MIL-P-63235(AR)
AMENDMENT 4
21 JUNE 1985

SUPERSEDING
AMENDMENT 3
16 May 1983

PROJECTILE, GUIDED, 155MM, XM712
THERMAL BATTERY FOR

This amendment forms a part of Military Specification MIL-P-63235(AR), dated 31 August 1979, and is approved for use by the US Army Armament, Munitions and Chemical Command and is available for use by all Departments and Agencies of the Department of Defense.

Figure 1. +11 volt power source voltage and load profiles (0 to 100 seconds)

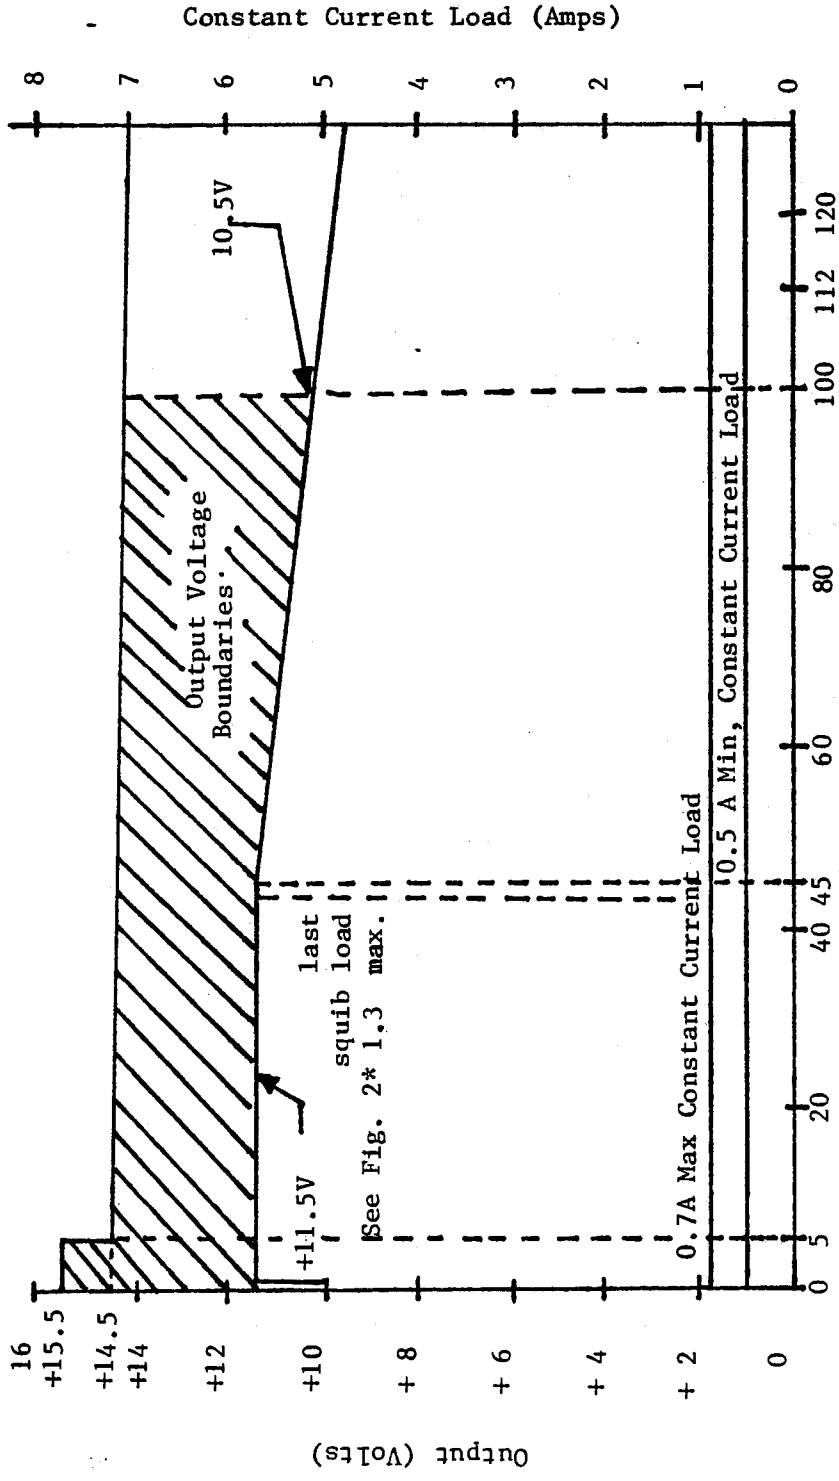
Delete Figure 1 entirely and substitute the included Figure 1.

Figure 2. +11V power source voltage and load profiles (0 to 1.5 seconds)

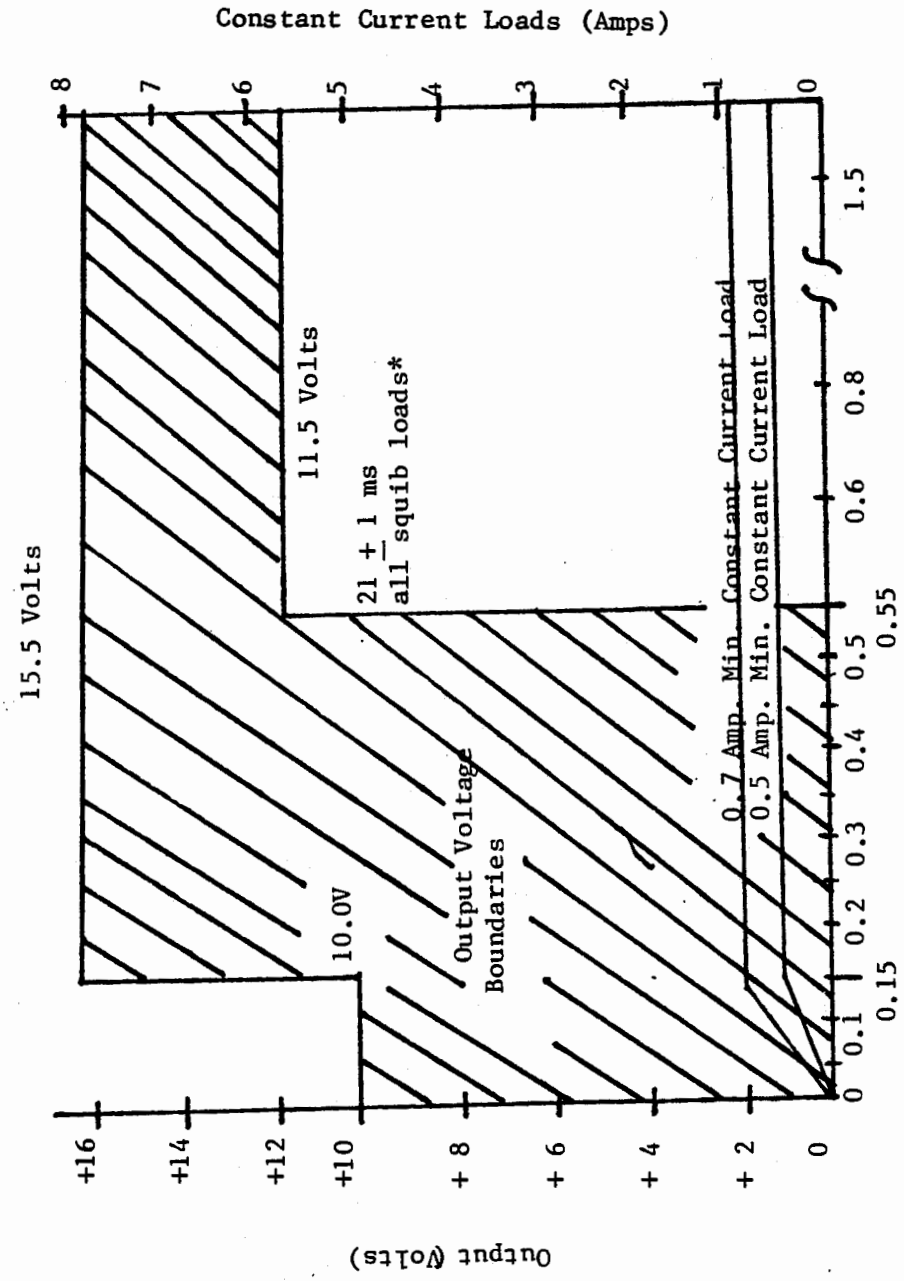
Delete Figure 2 entirely and substitute the included Figure 2.

Figure 3. +30 volt power source voltage and load profiles (0 to 70 seconds)

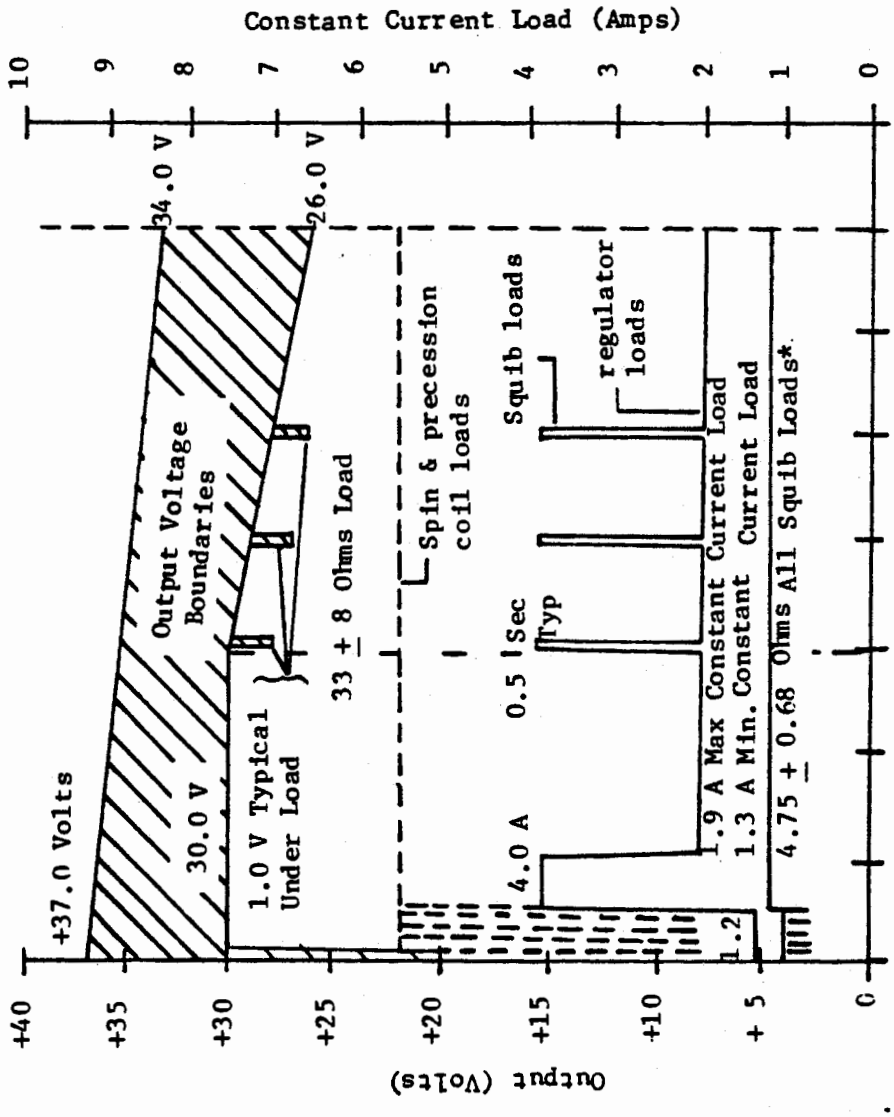
Delete Figure 3 entirely and substitute the included Figure 3.

Figure 4. +30 volt power source voltage and load profiles (0 to 5.5 seconds)
(typical squib pattern shown)

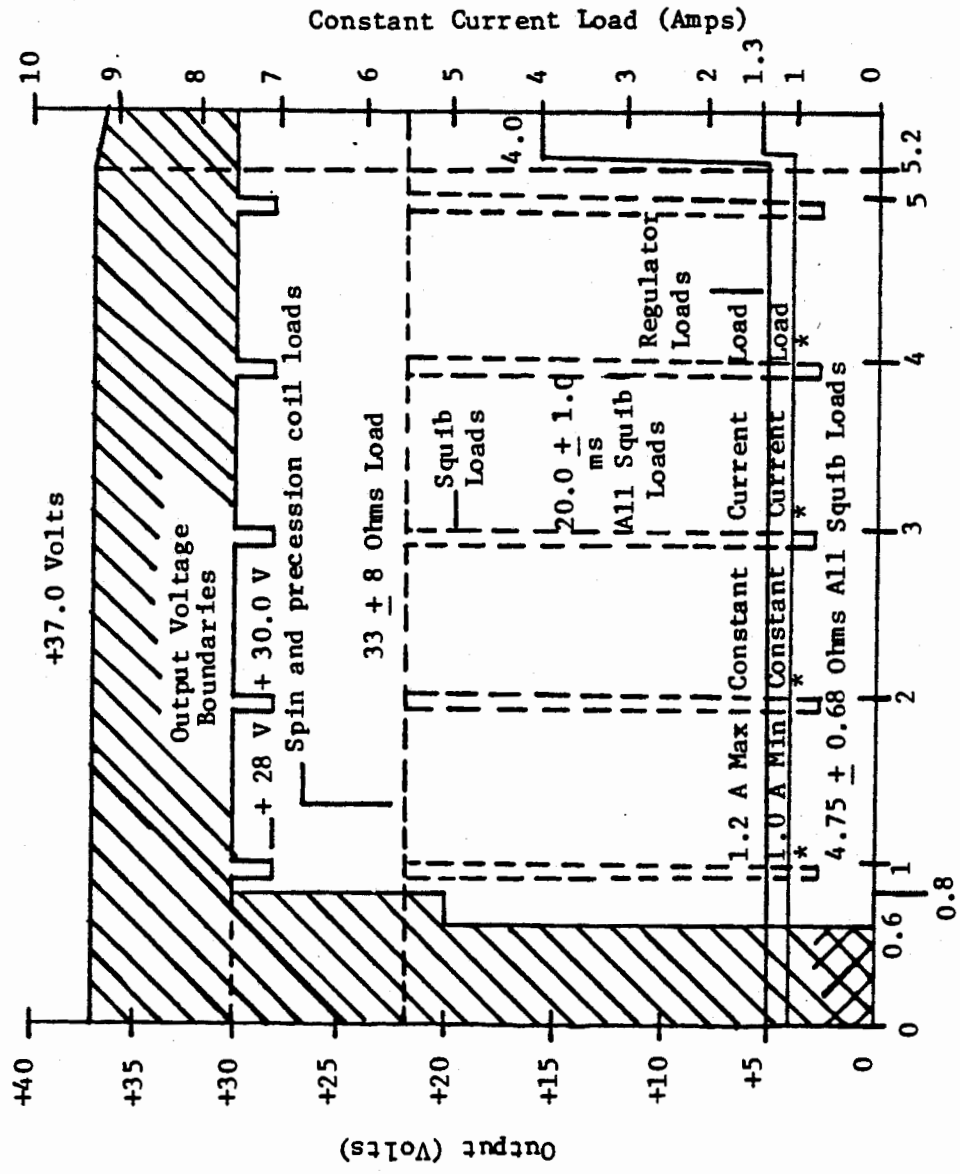
Delete Figure 4 entirely and substitute the included Figure 4.

Figure 5. -30 volt power source voltage and load profiles (0 to 70 seconds)

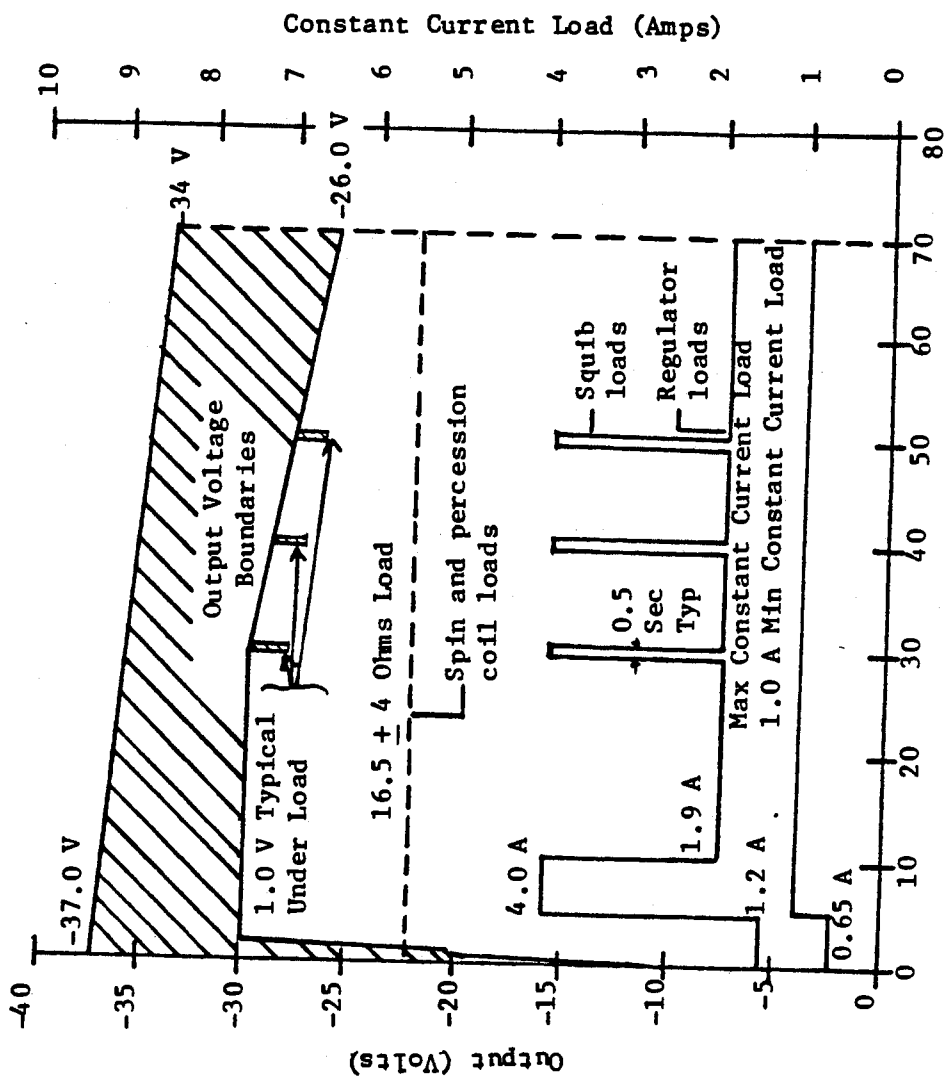
Delete Figure 5 entirely and substitute the included Figure 5.

Figure 6. -30 volt power source voltage and load profiles (0 to 70 seconds)

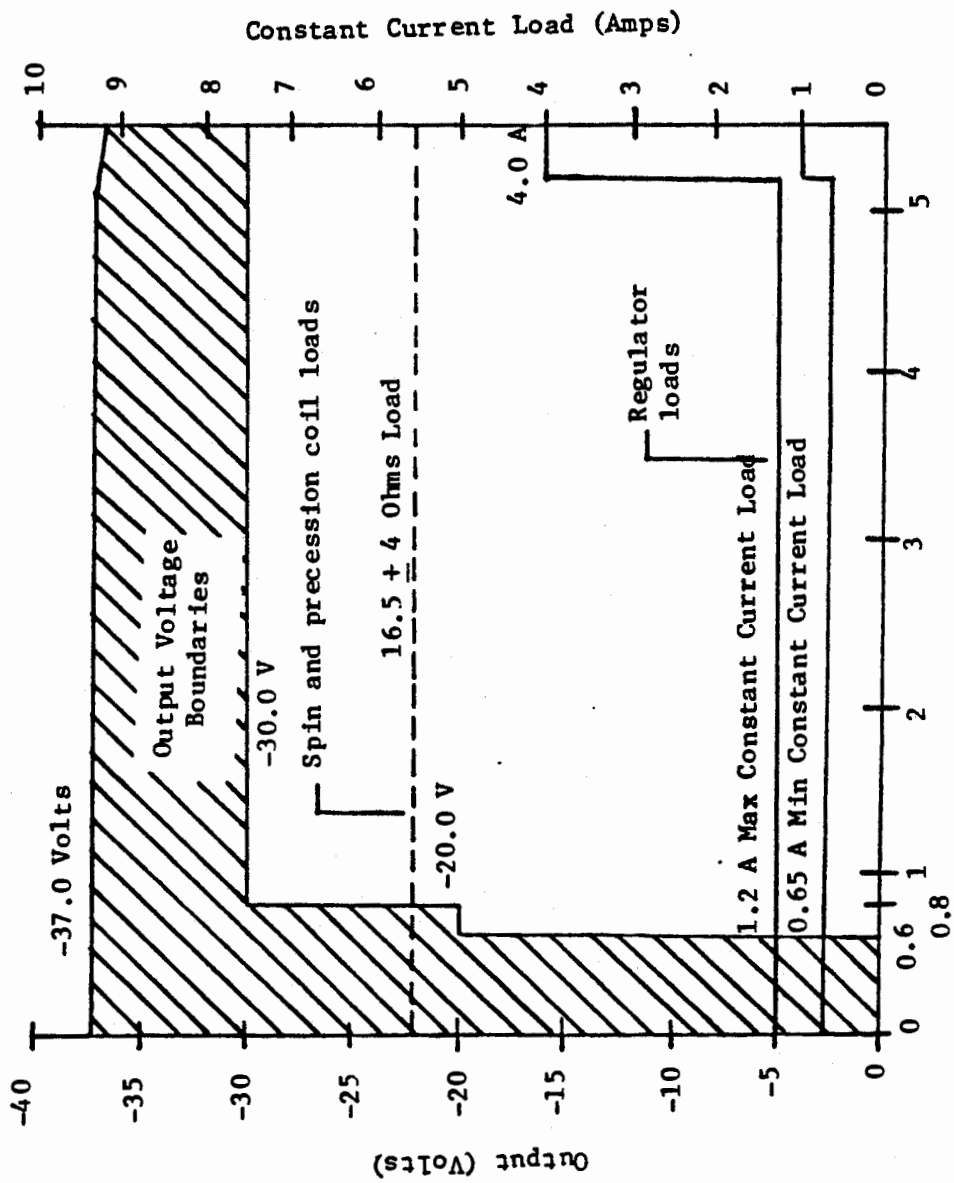
Delete Figure 6 entirely and substitute the included Figure 6.

Figure 7. output voltage rise time boundaries for +11 volt source

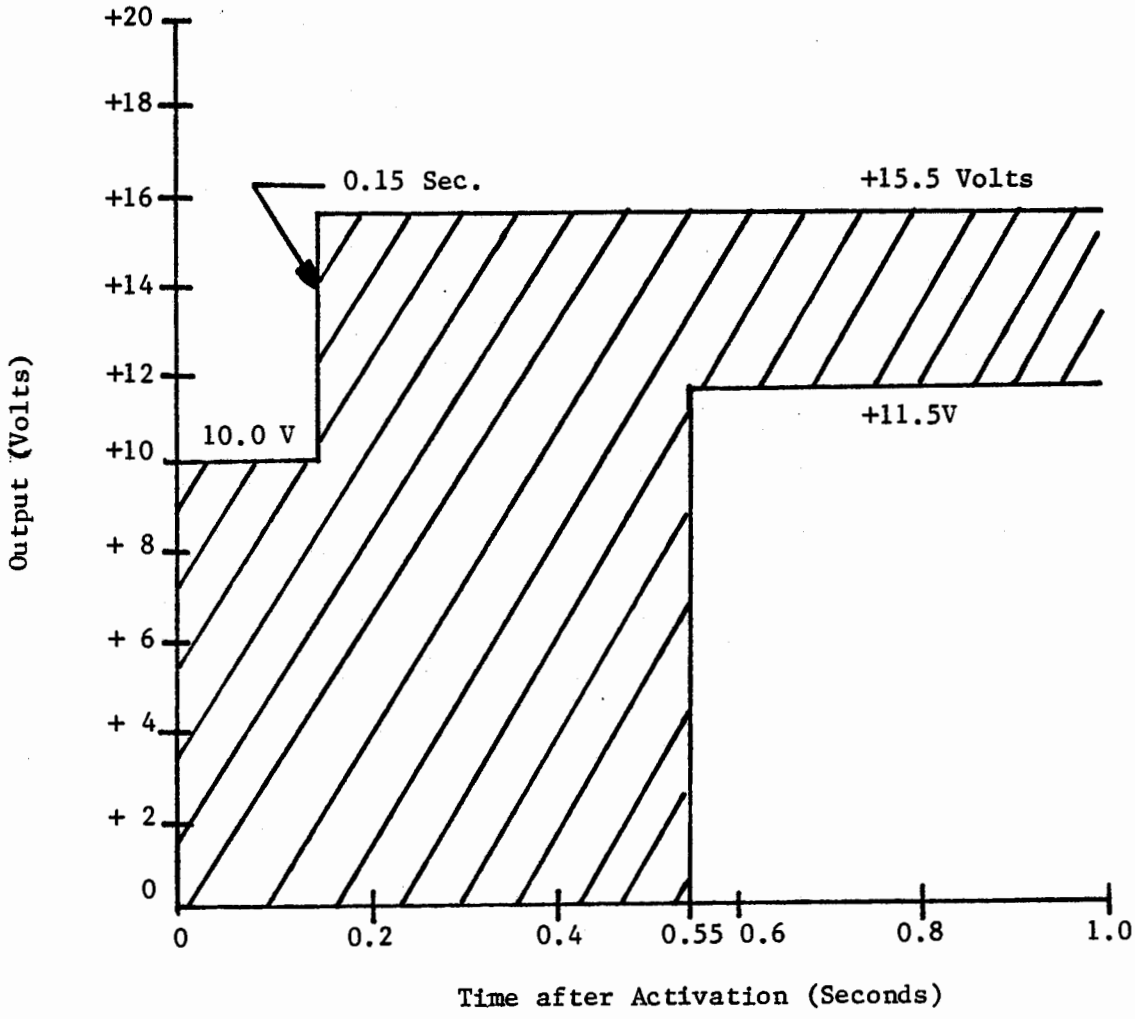
Delete Figure 7 entirely and substitute the included Figure 7.
